From: John Lawson
Sent: 3/12/2023 2:28:31 PM
To: Council Northernbeaches Mailbox
Subject: TRIMMED DA2023/1023 32 Loblay Crescent Bilgola Plateau Submission opposing the Development Application - revised Architectural Plans and Revised Arborist Report
Attachments: D03 - Revised.pdf; New Sandstone steps impact in our bedroom.jpg; 231130 Flowering Lilli Pilli at front 34 Loblay 2.jpg; 231201 G3 Lilli Pilli roots.jpg; 231201 G3 Lilli Pilli view looking south.jpg; 231201 Lilli Pilli G3 roots P3.jpg; 231201 Tree fern in G3 location not picked up in Arborist rpt.jpg; 231201 Viburnum G2 trees- wall.jpg; 231201 Viburnum roots.jpg; 231201 Viburnum tree root .jpg; Tree 1 P3 root .jpg; Tree 1 P2.jpg; Tree 1 P1.jpg;

1. Revised Architectural Drawings DA 01A/ 02A and 03/A

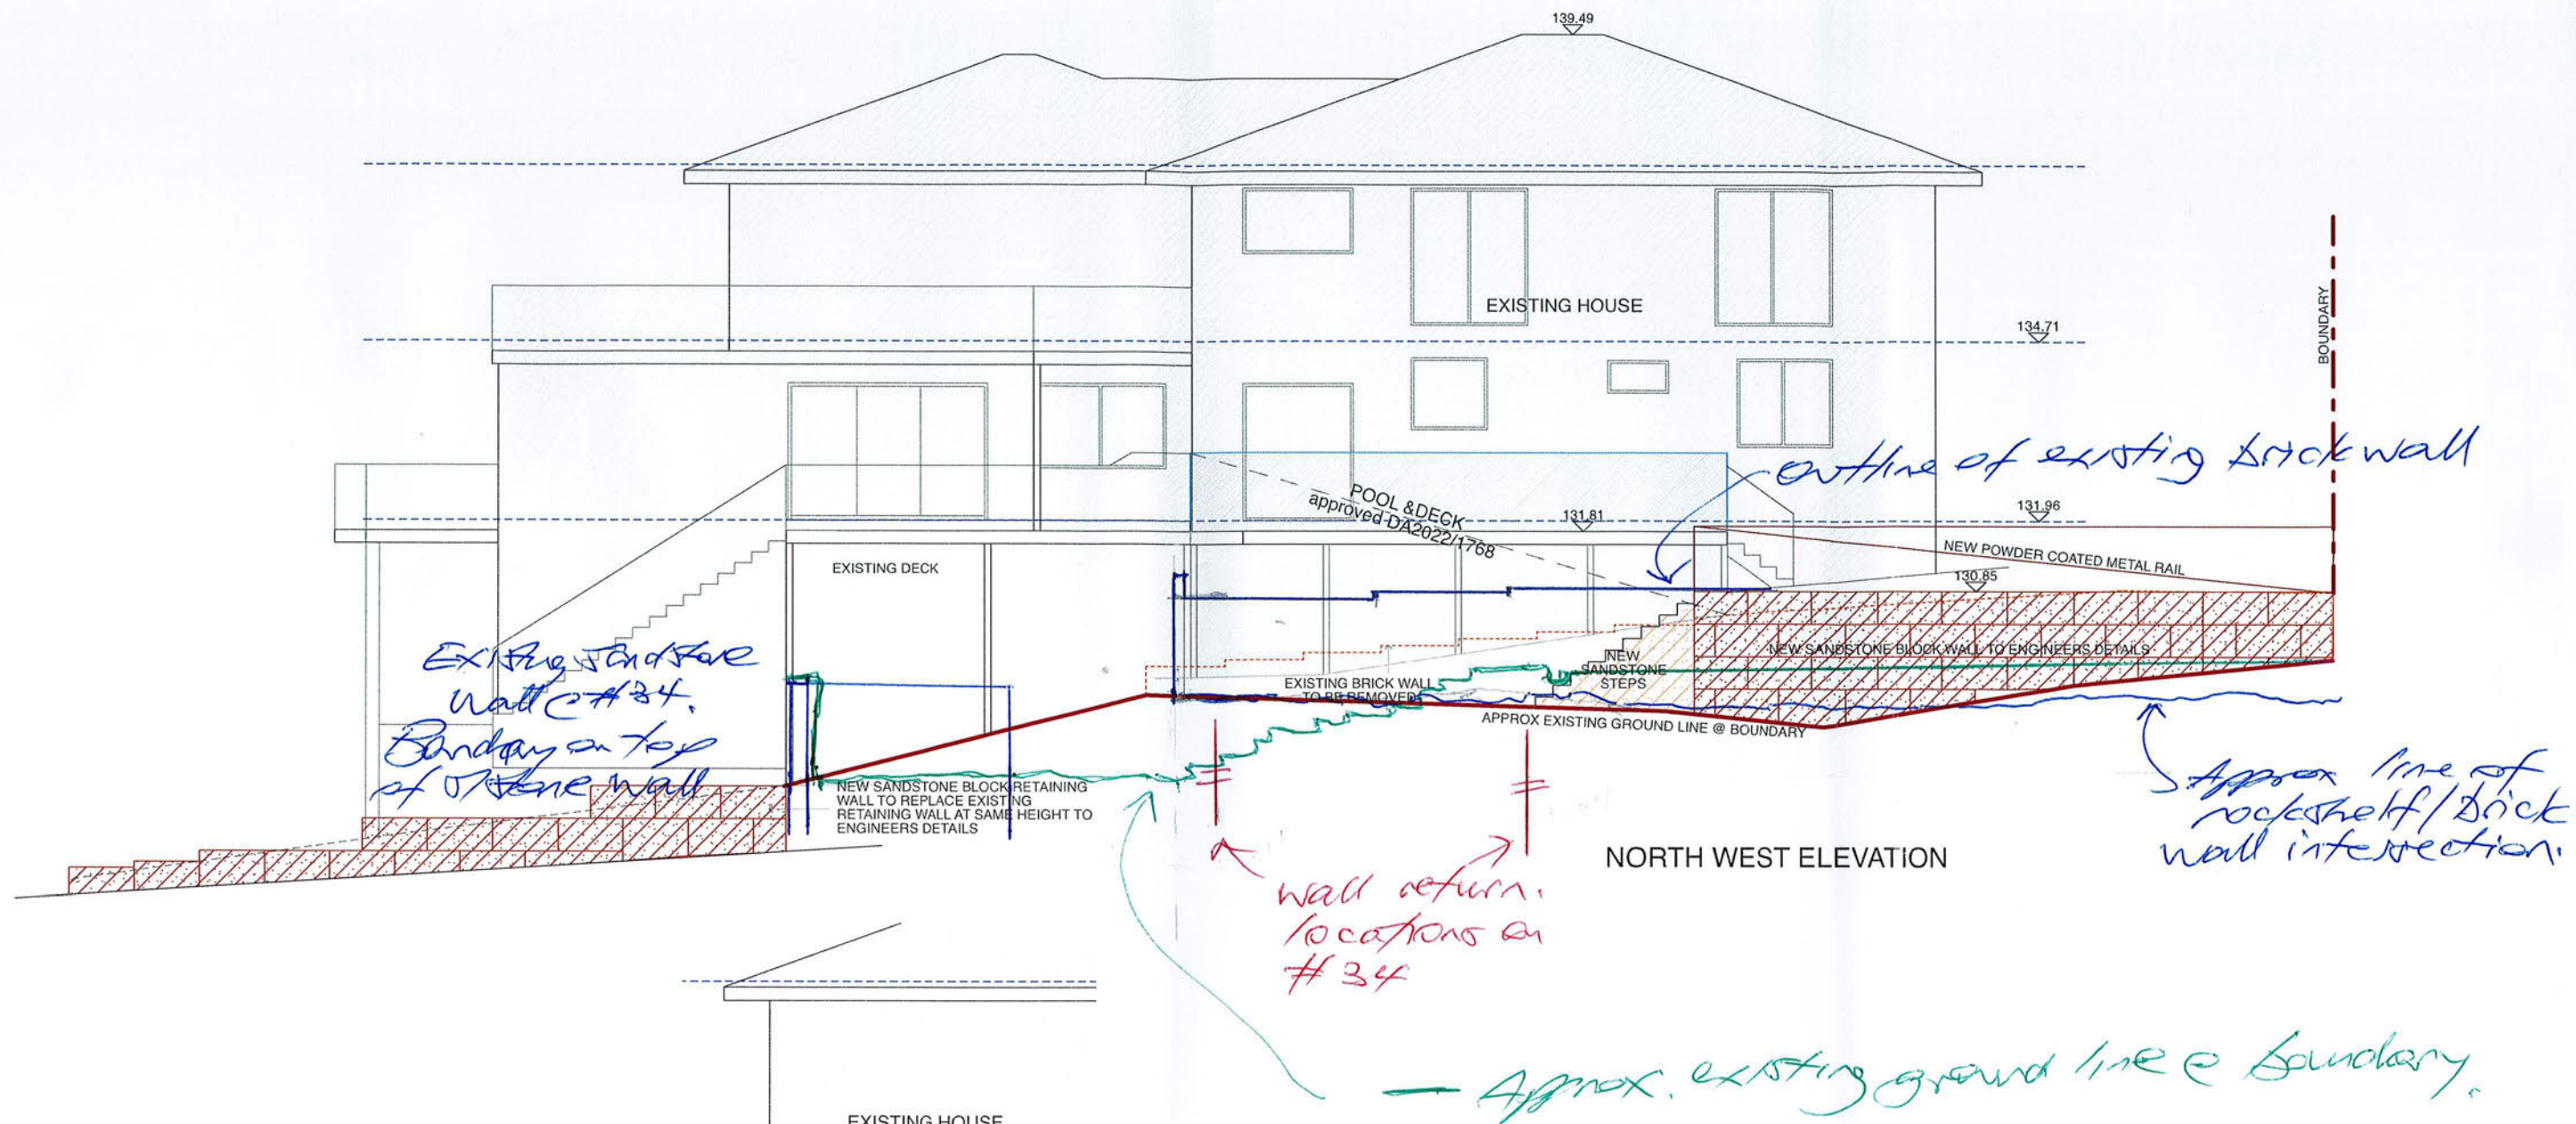
- I advise again that the shown levels of the existing brick retaining wall and the actual existing ground levels, as well as our sandstone steps leading to our rear yard are either not shown or are incorrect. Please see again the attached hand drawn sketch of DA-03 Revised 12-8-23 showing the correct situation (file D-03 revised) . Further to this also please review previous photos that show the existing rock outcrops that would be covered by a fence as well as photos of our existing steps/ landscape infrastructure that would be damaged/ requiring rectification / rebuild in order for us to gain access to our rear yard.

- Further I highlight again the effect that the applicants sandstone steps will have on enabling the applicant to view into our northeast bedroom via the skylight as well as via south facing windows due to the elevation of the steps. Please see the attached photo taken from inside bedroom looking towards the steps though the skylight in the roof.

- Again, no information re Engineers Details re the sandstone wall construction / footings and their impact on Tree1 as well as again the drainage aspects involved.
